[Instrument Panel] (LHD)

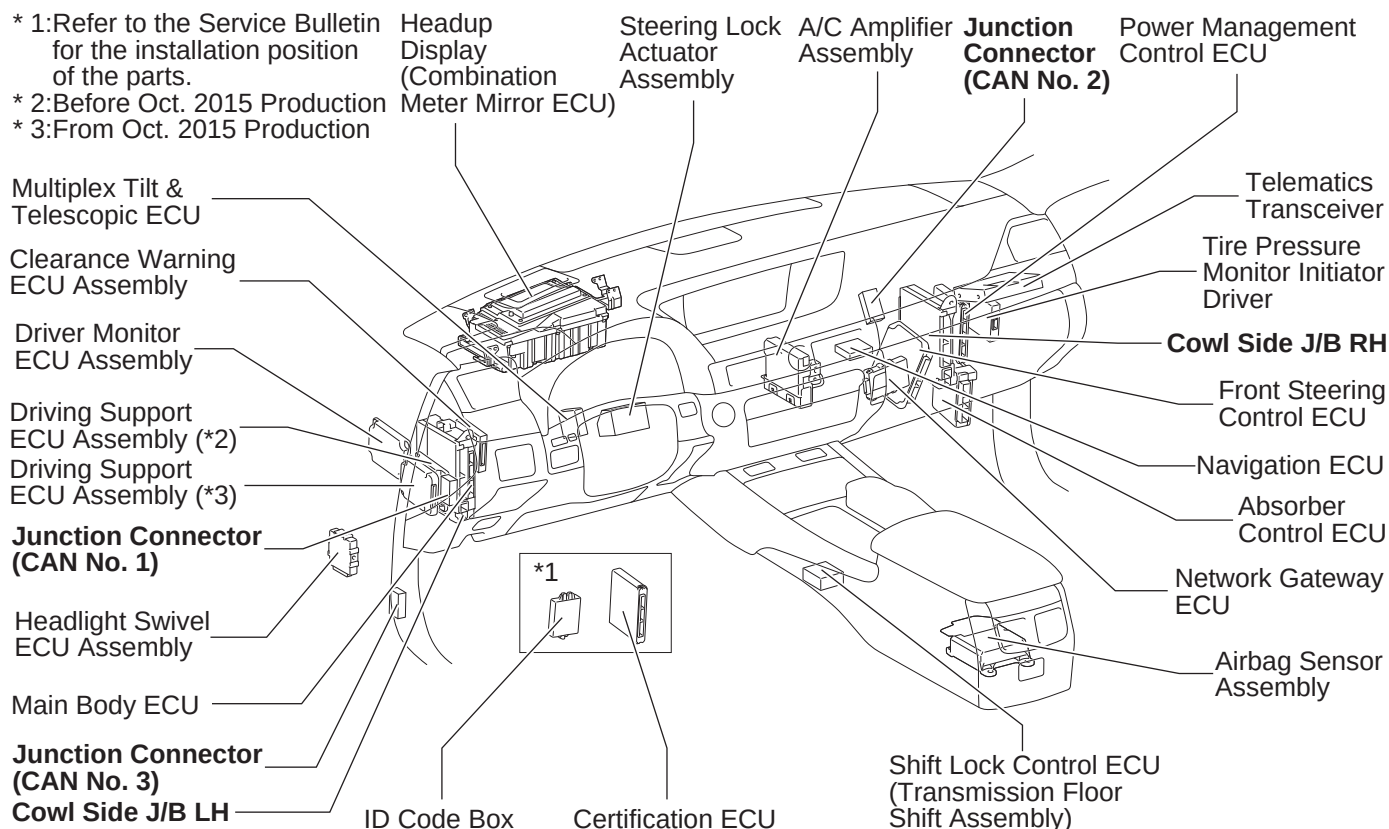
* 2: Before Oct. 2015 Production

* 3: From Oct. 2015 Production

* 1: Refer to the Service Bulletin for the installation position of the parts.
